**BOARD OF ARCHITECTURAL REVIEW
AGENDA
August 18, 2016 - 4:00 PM
Council Chambers - Rouss City Hall**

BOARD OF ARCHITECTURAL REVIEW MINUTES

1
LE-4
TOP OF SMOKESTACK
SCALE: 1/4" = 1'

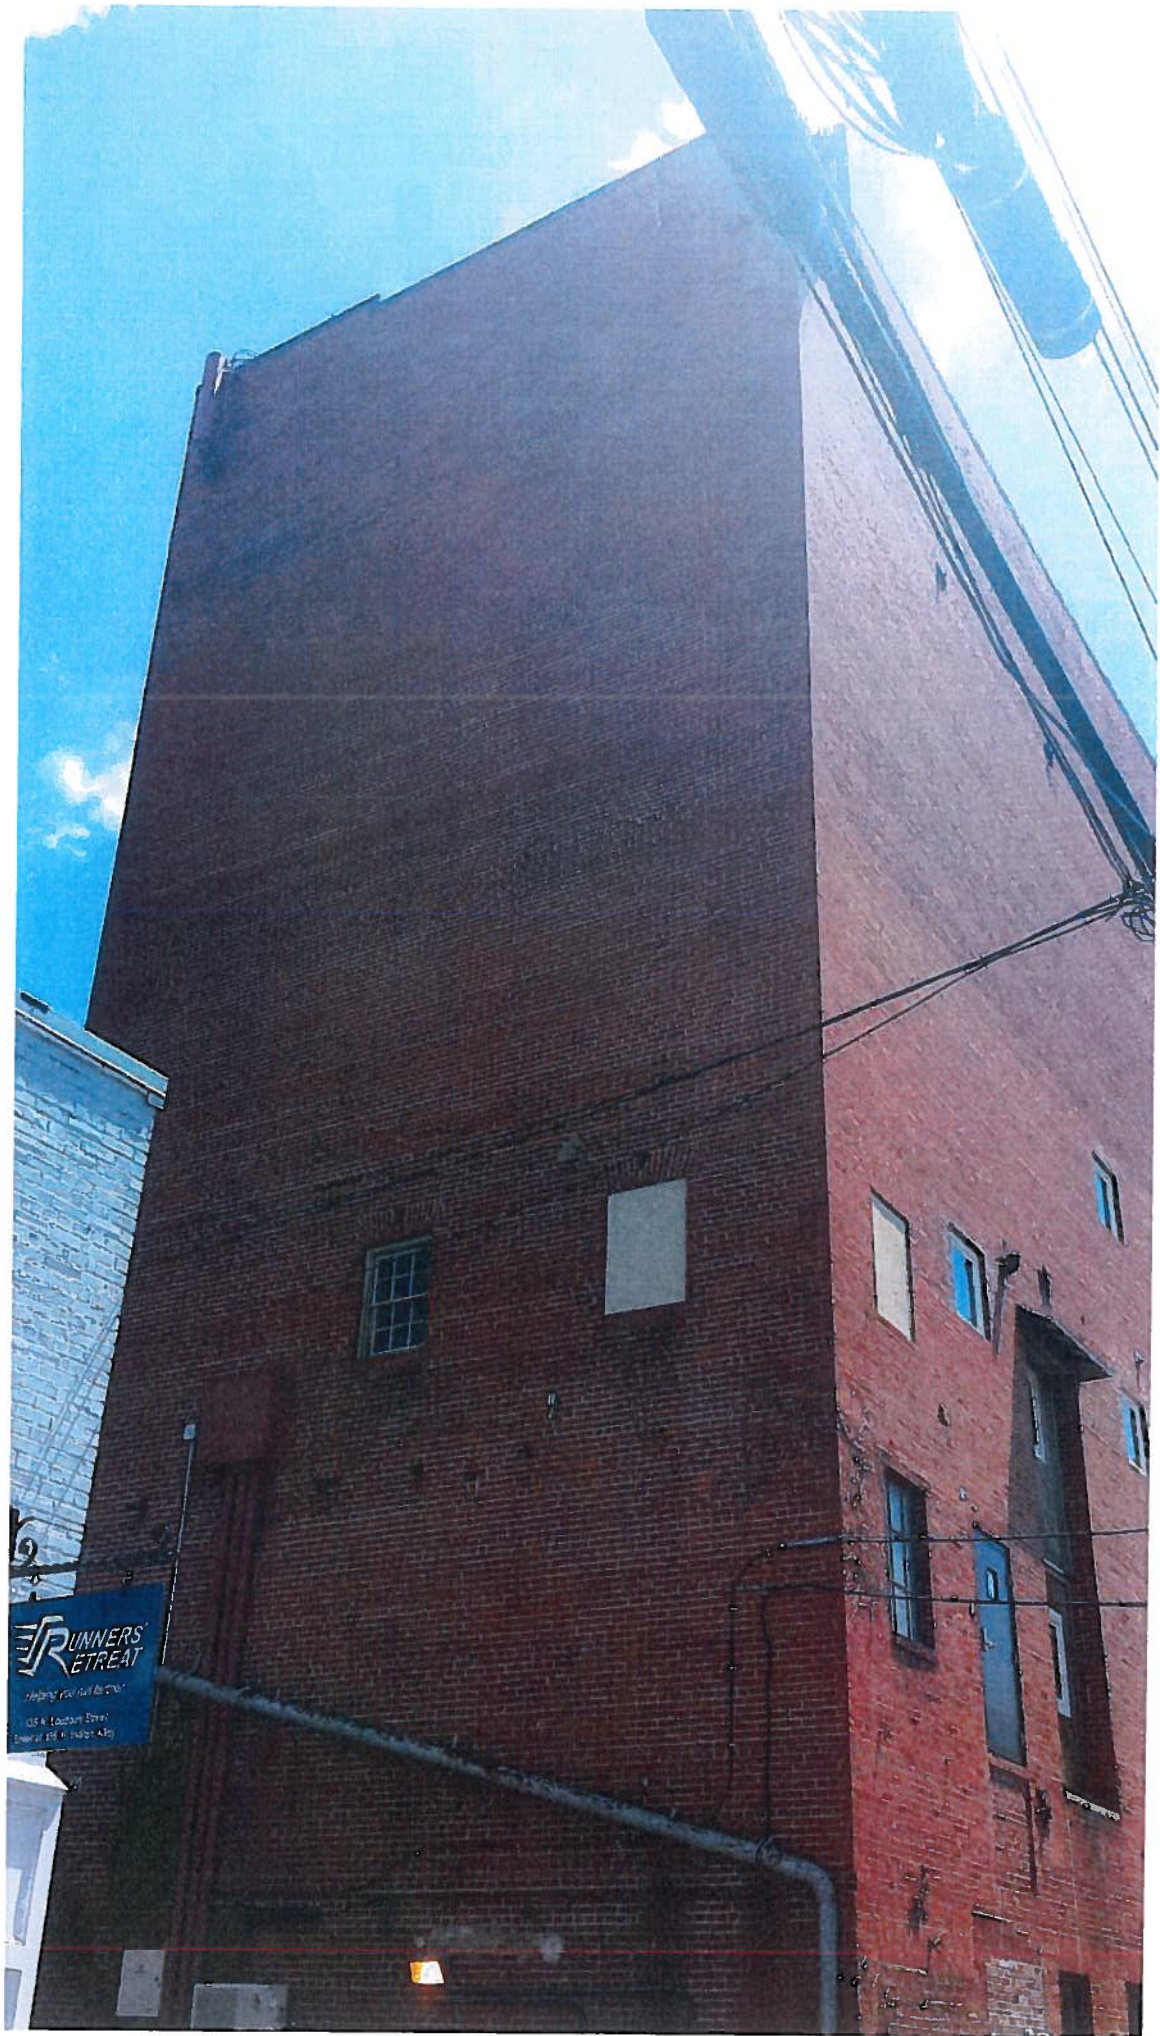
Need to include the future RRUs. 2 per sector, total of 6

Beta azimuth is 140 not 60.
